# Exelon Generation®

Subject: Comments Concerning Concentration Averaging and Encapsulation  
Branch Technical Position (81FR3166, dated January 20, 2016,  
Docket ID NRC NRC-2011-0022)

Comments Concerning Concentration Averaging and  
Encapsulation Branch Technical Position

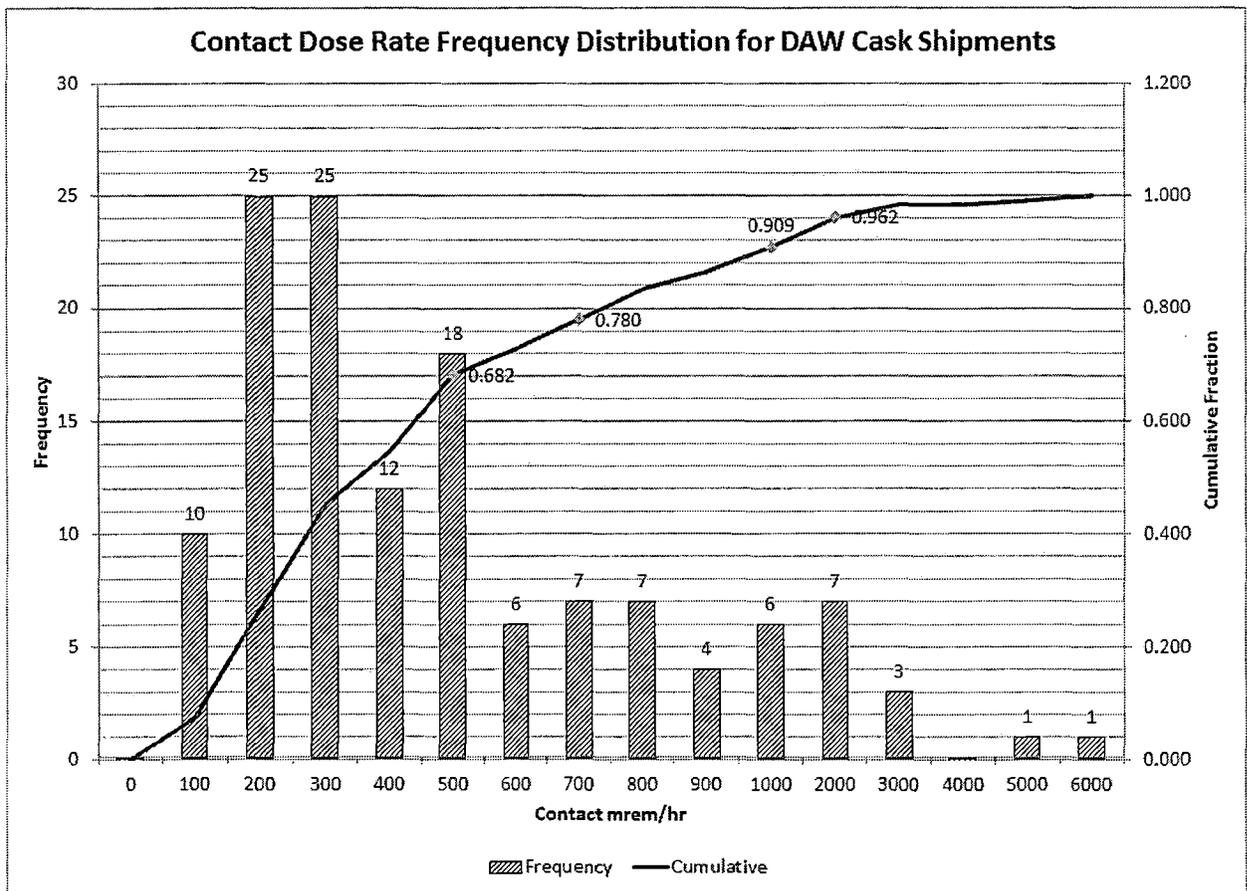
The following figure provides a distribution of contact dose rates of waste items for two different cask shipments of DAW to a waste processor. Current procedures require DAW with dose rates >300 mrem/hr at 30 cm to be put in a shielded container which skews the distribution towards higher dose-rate DAW. Sites typically generate one liner of high dose-rate DAW each refueling outage (~1/yr).
